**Re: Creative Housing XIII, Franklin County**

This letter is written in follow-up to a construction storm water inspection that I conducted at the Creative Housing XIII project that is located at the end of Lamplighter Drive, in Grove City, Ohio. The inspection was conducted on September 16, 2011. The purpose of the inspection was to evaluate compliance with the General Storm Water Permit Associated with Construction Activities.

**Creative Housing XIII**  
**Install concrete wash-out pit**  
**Scioto River Watershed**  
**September 16, 2011**  
**Photo by: Greg Sanders**

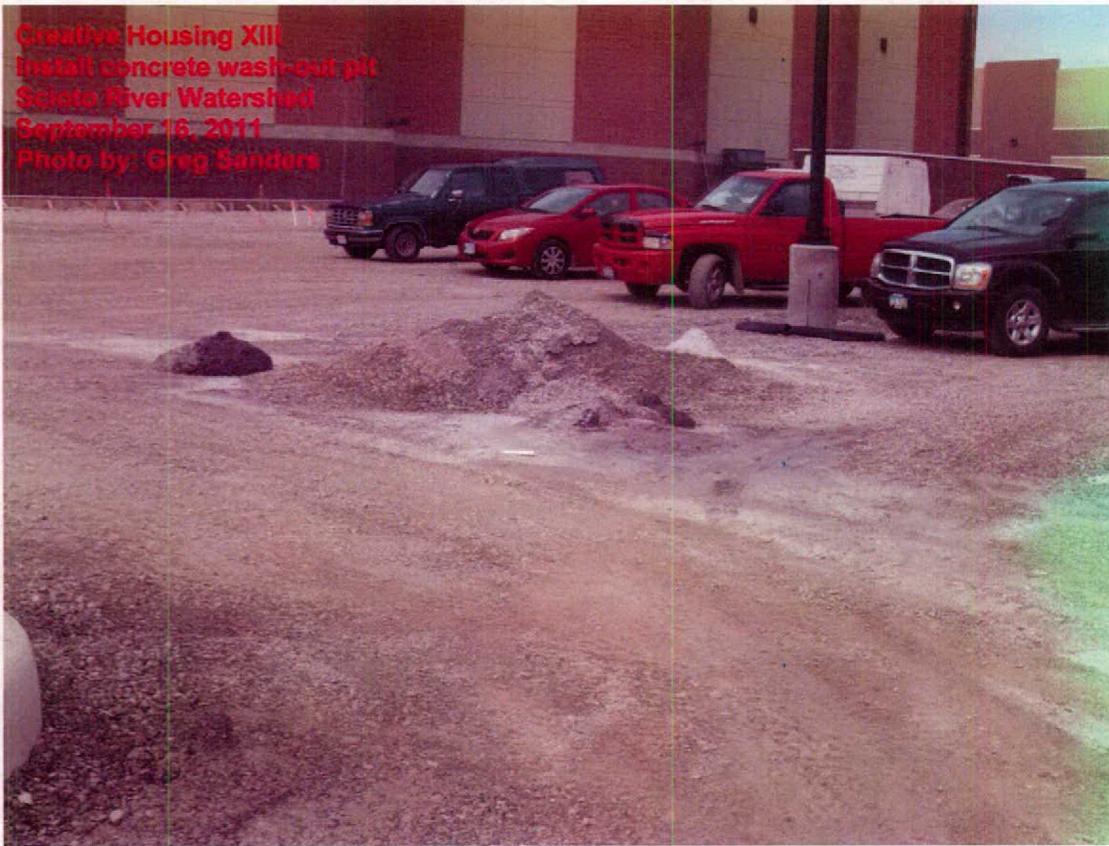
Please install a concrete wash-out pit. Concrete wash-out was noted being discharged on to the ground without controls. Please see attached picture.
